Proposal Number: 2021-OA-001

**The OESC 28th Edition
Proposals for Ontario Amendments**

Specification 9.2
Primary 1-phase line angle 4° to 15° (pin insulator),
2.4 to 8.0 kV, maximum span 90 m (300 ft)
(See Rule 75-200.)

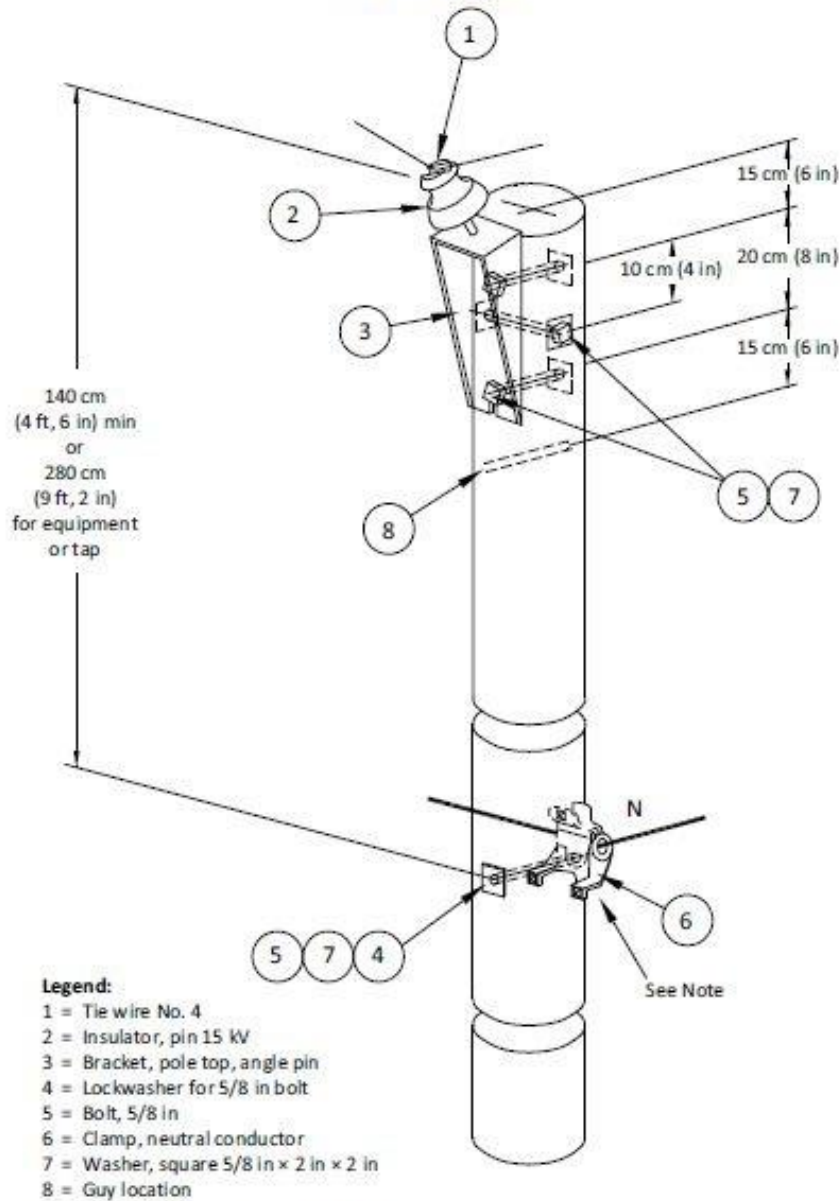
Note: See alternate Specification ~~35~~ 35.1

Specification 10.1
Primary 1-phase tangent (LP insulator), 2.4 to 16 kV, maximum span 90 m (300 ft)
(See Rule 75-200.)

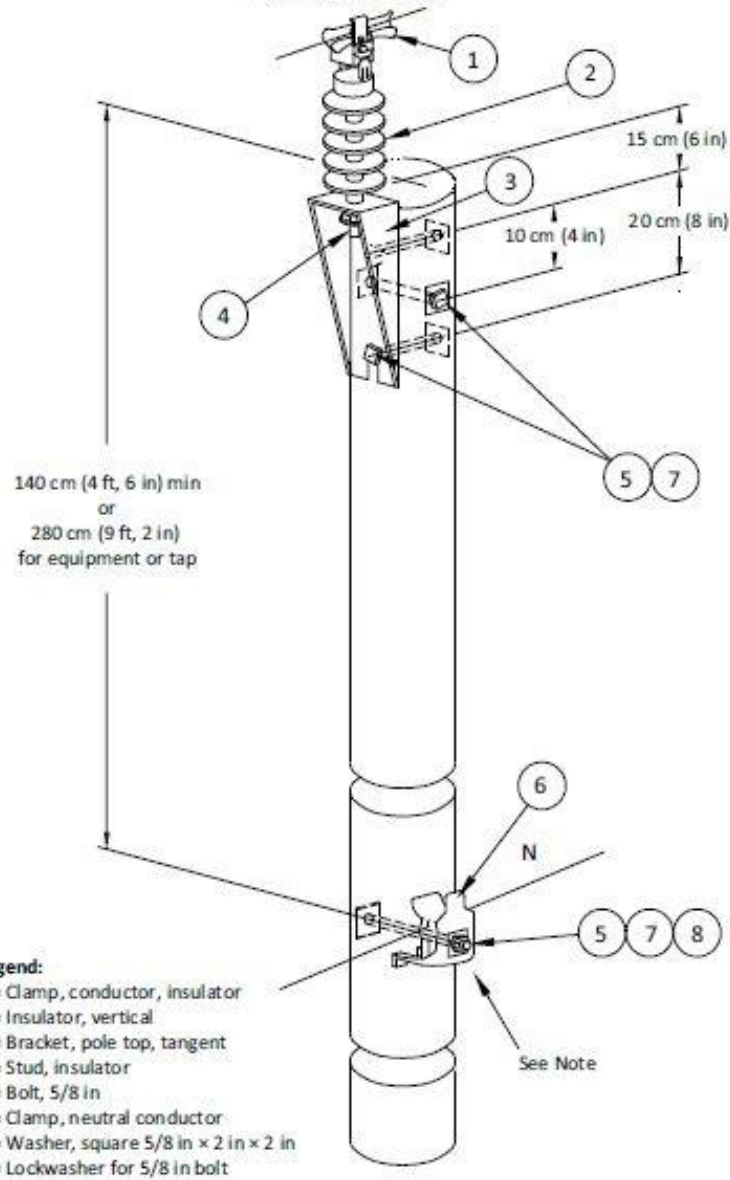
Note: See alternate Specification ~~35.1~~ 35.1

Specification 10.5
Primary 1-phase dead-end, 2.4 to 16 kV, maximum span 90 m (300 ft)
(See Rule 75-200.)

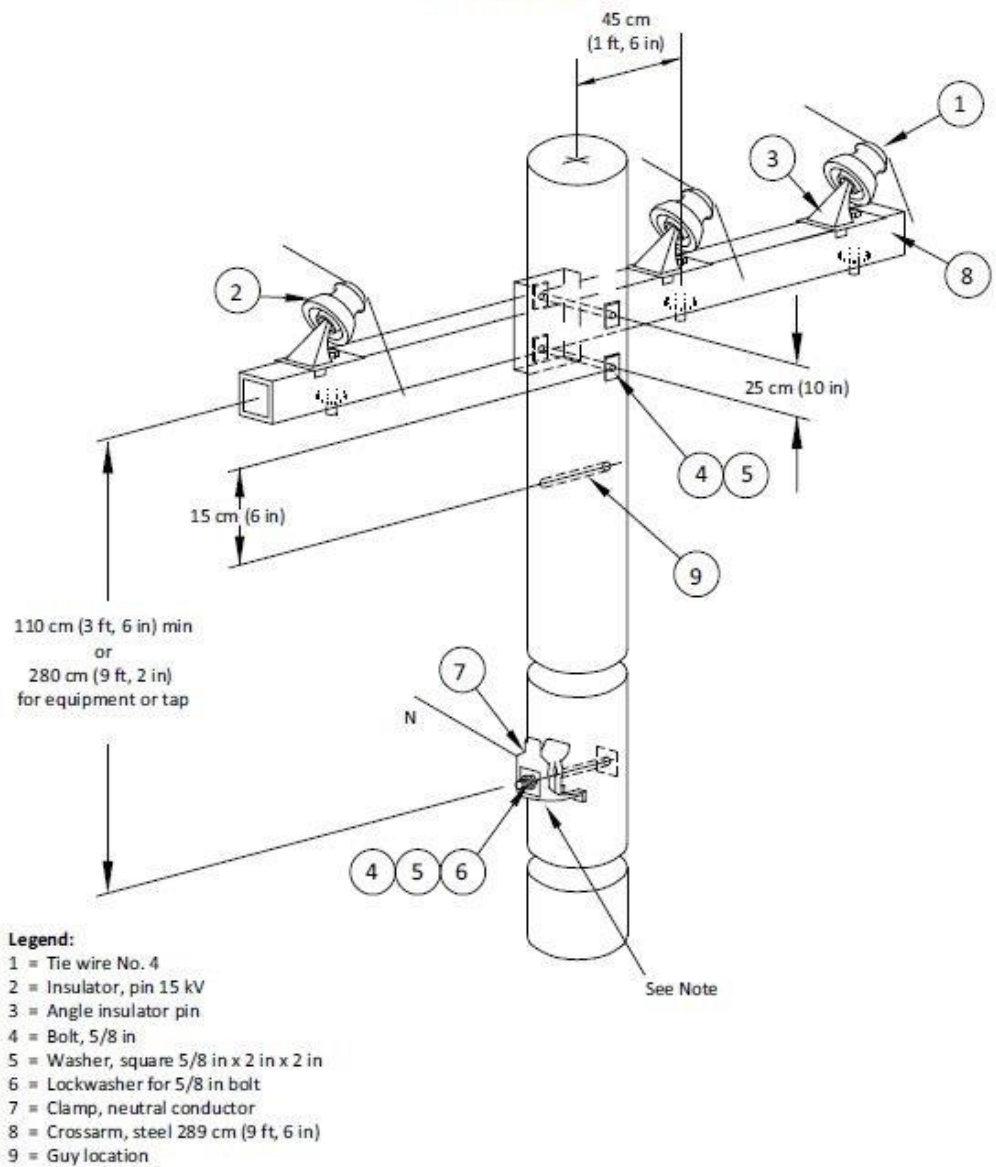
Note: See alternate Specification 35.1

Specification 11.2
Primary 3-phase, line angle 4° to 15° crossarm (pin insulator), 2.4/4.16 to 8.0/13.8 kV
(See Rule 75-200.)

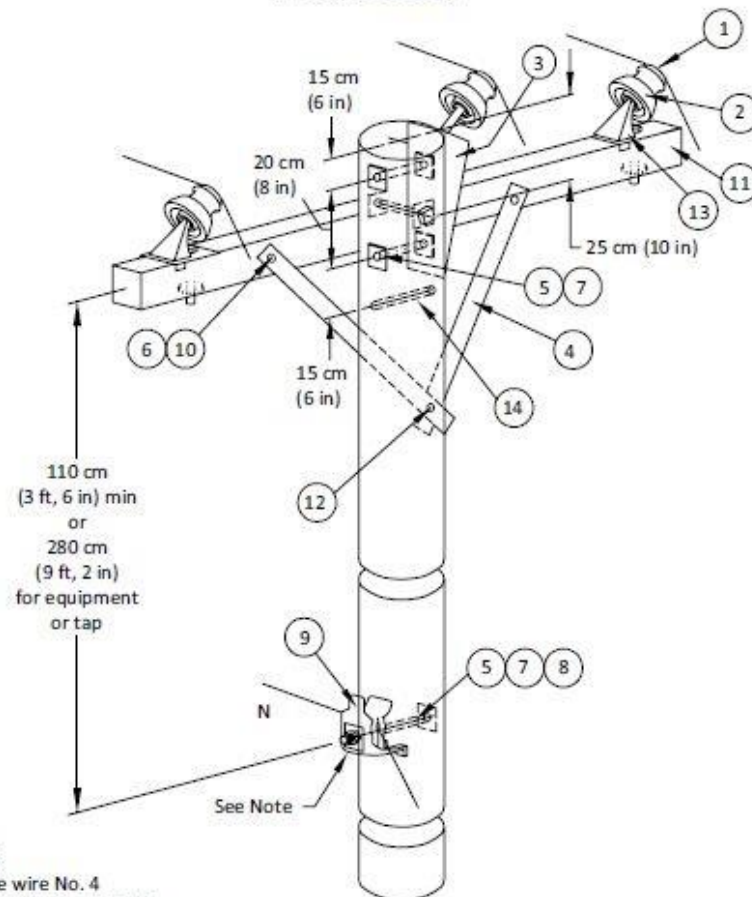
Note: See alternate Specification ~~38~~ 35.1

Specification 11.3
Primary 3-phase, underbuilt tangent crossarm (pin insulator), 2.4/4.16 to 8.0/13.8 kV,
maximum span 60 m (200 ft)
(See Rule 75-200.)

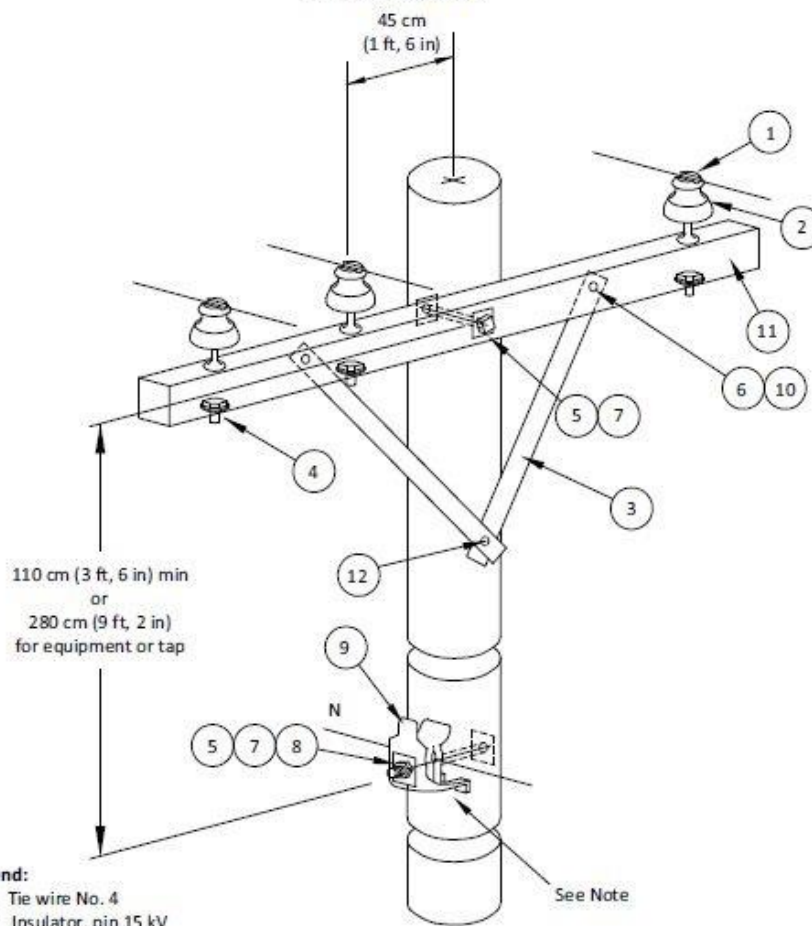
Note: See alternate Specification ~~35.1~~ 35.1

Specification 11.4
Primary 3-phase, tangent, crossarm (pin insulator), 2.4/4.16 to 8.0/13.8 kV
(See Rule 75-200.)

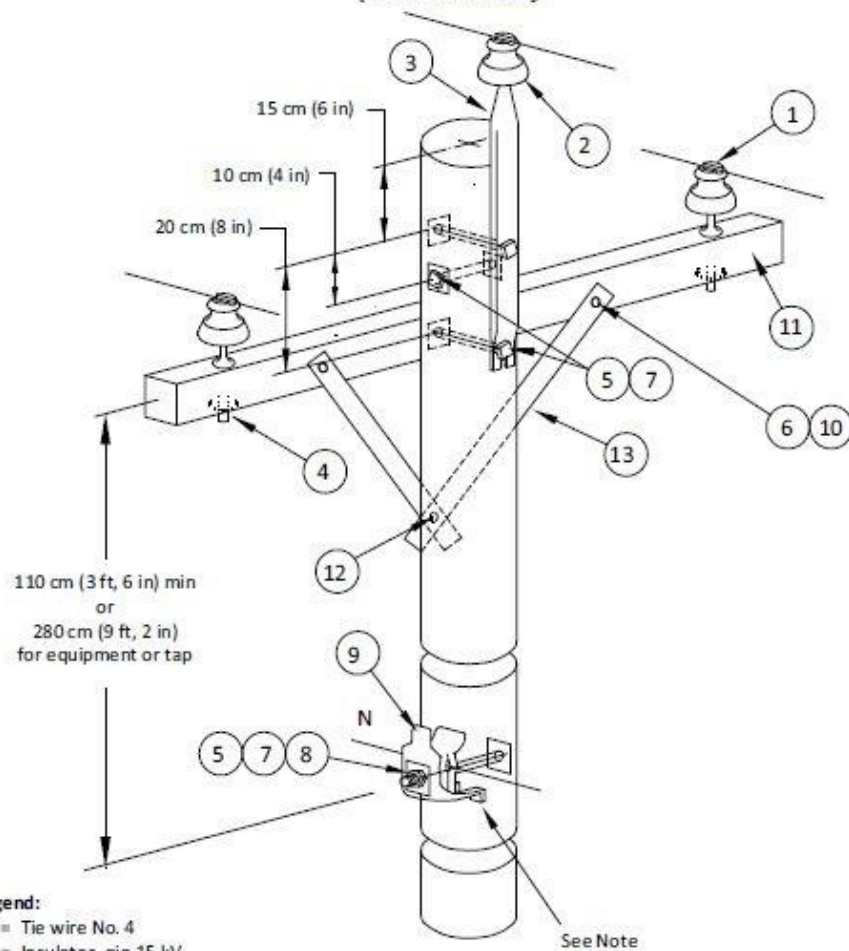
Note: See alternate Specification ~~39~~ 35.1

Specification 12.2
Primary 3-phase dead-end vertical, 2.4/4.16 to 16/27.6 kV
(See Rule 75-200.)

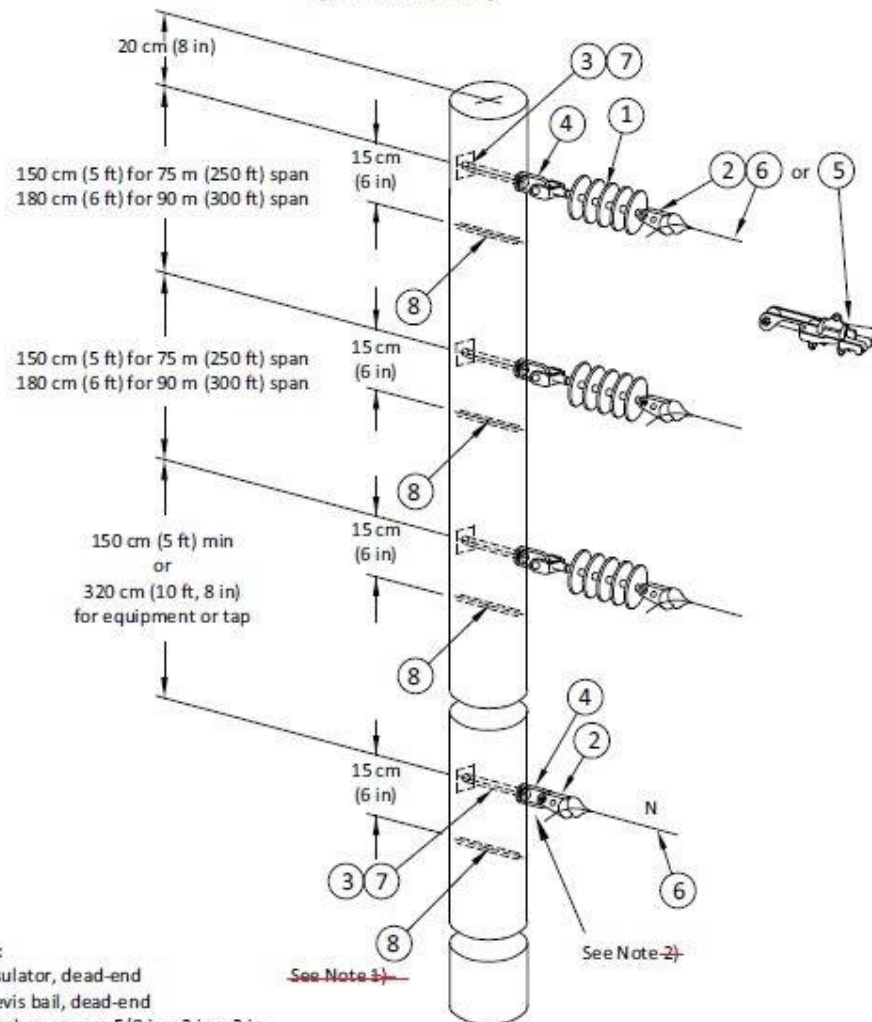
- 1) Guys under centre and bottom phases not required if conductors utilized are 1/0 AWG or smaller.
- 2) See alternate Specification 30. 35.1

Specification 13.1
Primary 3-phase line angle 4° to 15°, 2.4/4.16 to 16/27.6 kV
(See Rule 75-200.)

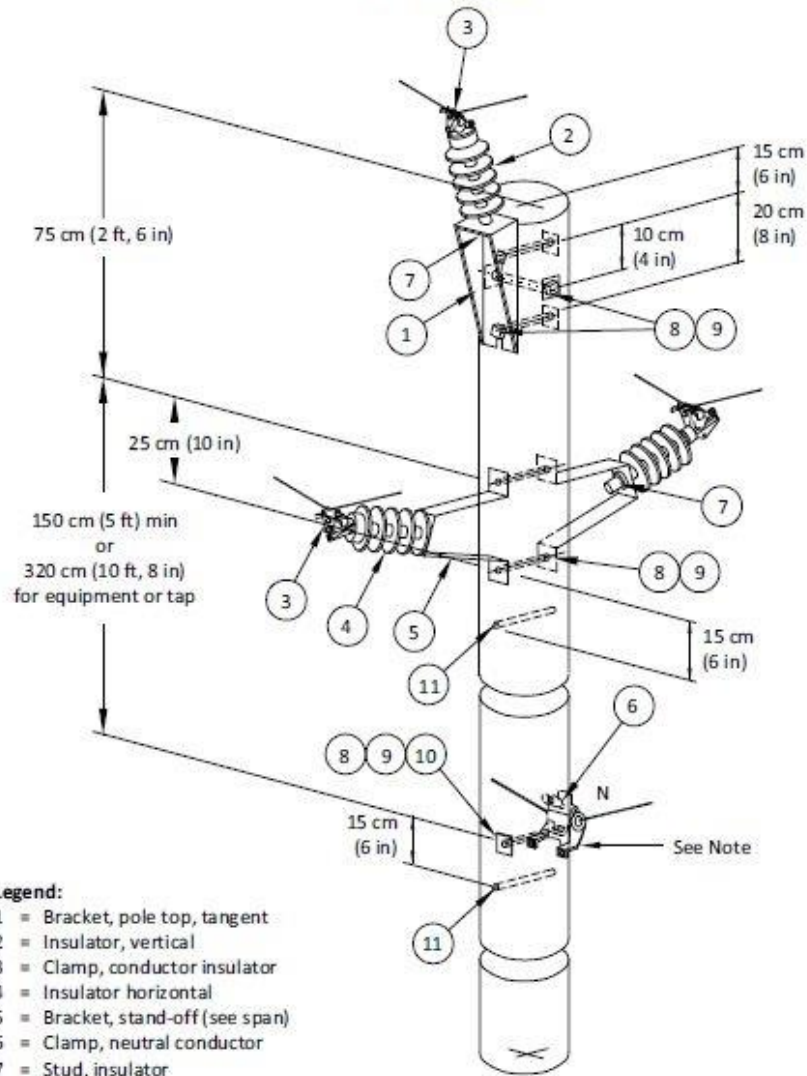
Note: See alternate Specification ~~35.1~~ 35.1

Specification 13.2
Primary 3-phase line angle 16° to 45°, 2.4/4.16 to 16/27.6 kV
(See Rule 75-200.)

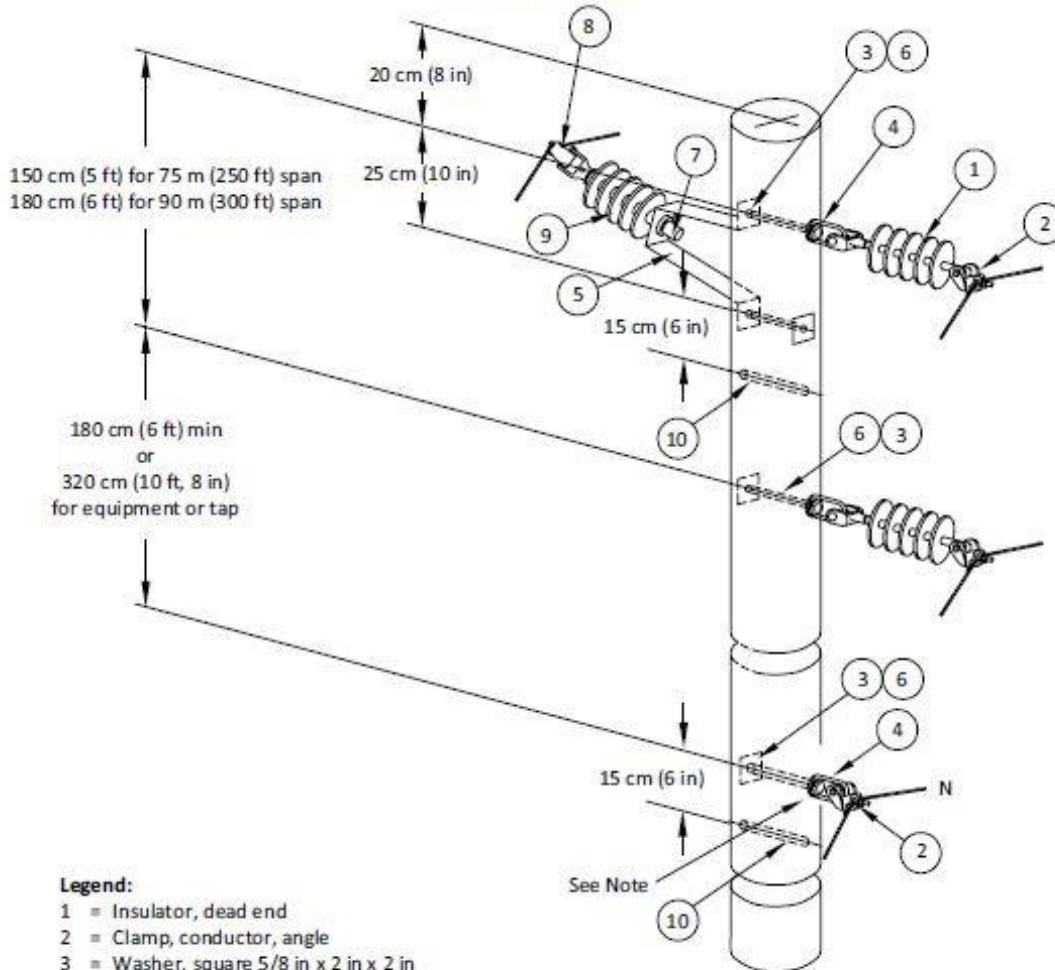
Note: See alternate Specification ~~35.1~~ 35.1

Specification 14.1
Primary 3-phase, tangent, crossarm (LP insulator), 2.4/4.16 to 16/27.6 kV
(See Rule 75-200.)

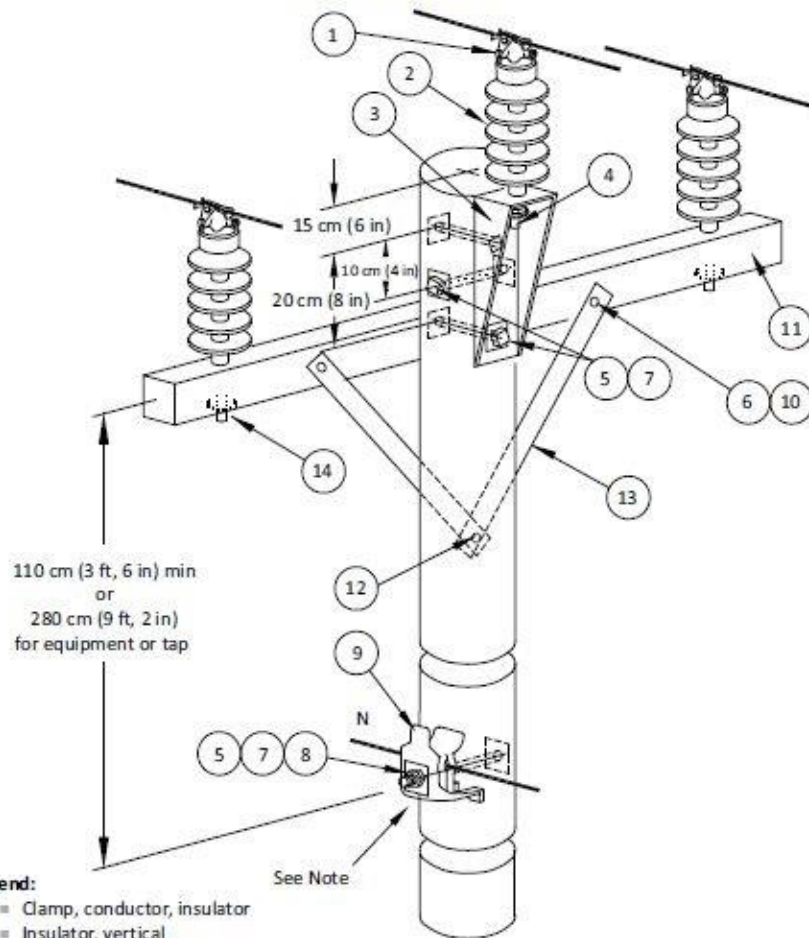
Note: See alternate Specification ~~35.35.1~~

Specification 14.3
Primary 3-phase dead-end, crossarm (triangular), 2.4/4.16 to 16/27.6 kV
(See Rule 75-200.)

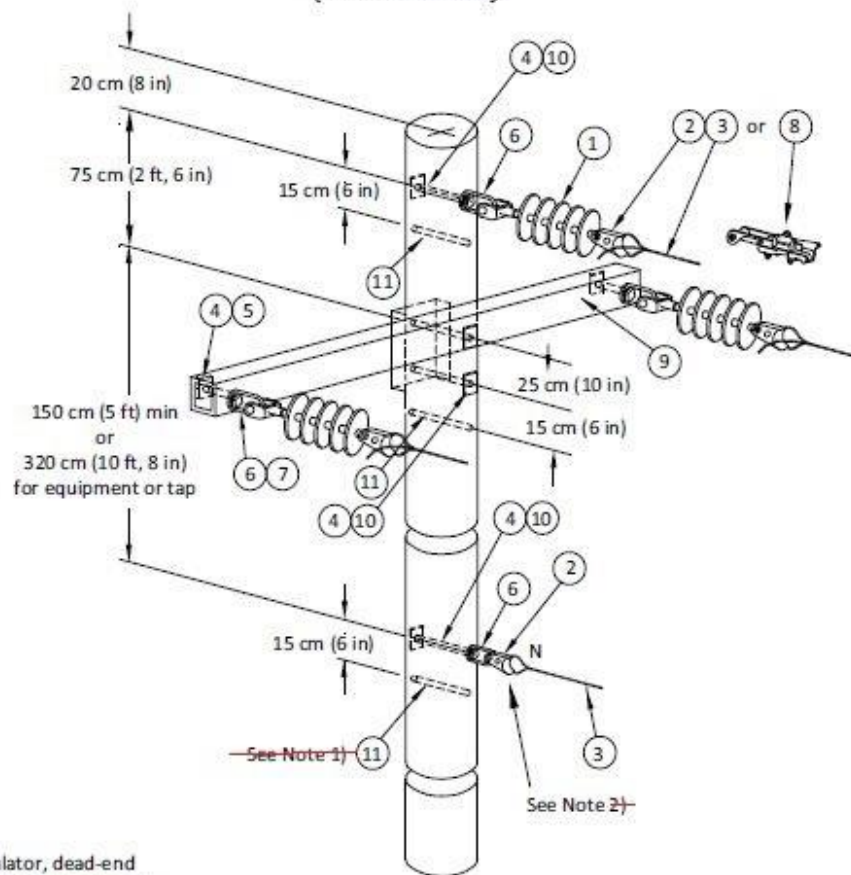
- 1) ~~Guy under neutral not required if conductors utilized are 1/0 AWG or smaller.~~
- 2) ~~See alternate Specification 36. 35.1~~

Specification 15.2
Primary 3-phase, underbuilt, tangent crossarm (LP insulator), 2.4/4.16 to 16/27.6 kV,
maximum span 60 m (200 ft)
(See Rule 75-200.)

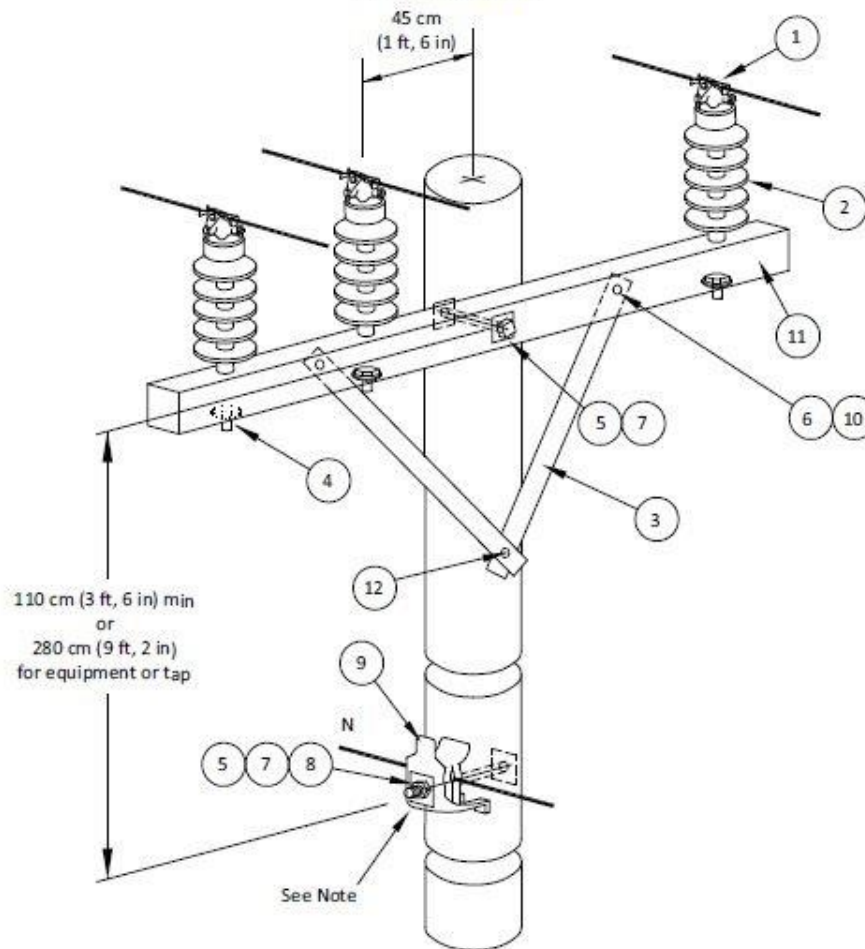
Note: See alternate Specification [35.1](#)

Specification 15.3
Primary 3-phase, underbuilt, line angle 4° to 15° crossarm (LP insulator), 2.4/4.16 to 16/27.6 kV, maximum span 60 m (200 ft)
(See Rule 75-200.)

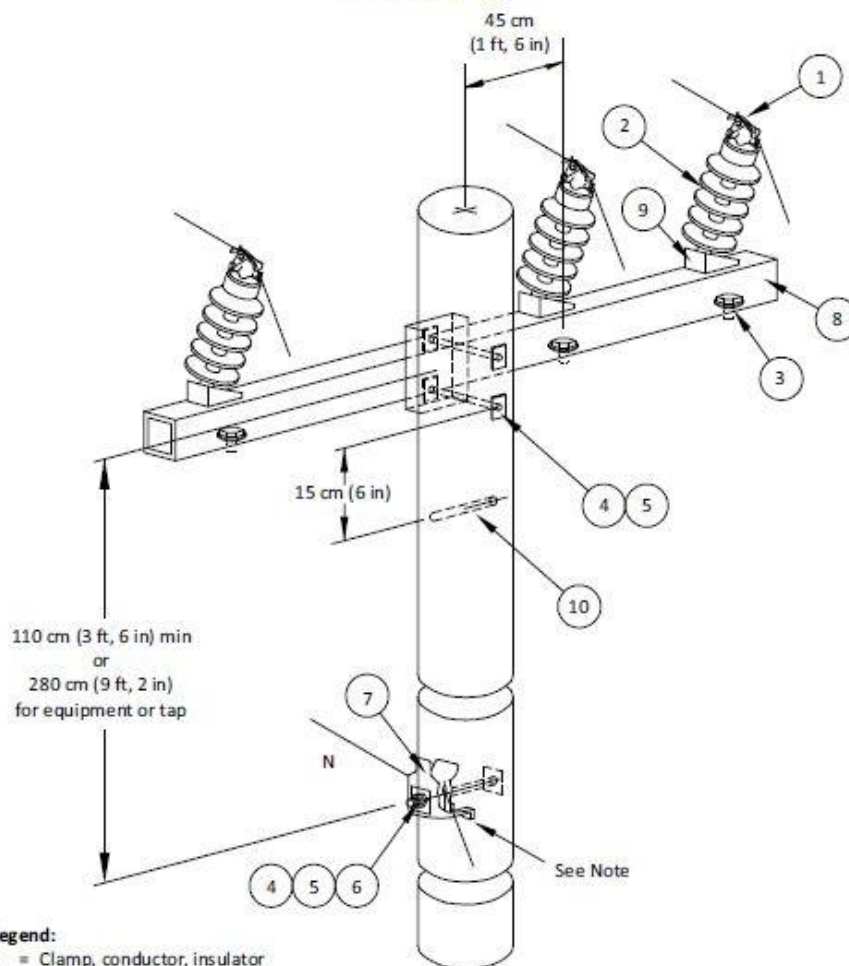
Note: See alternate Specification ~~35.1~~ 35.1
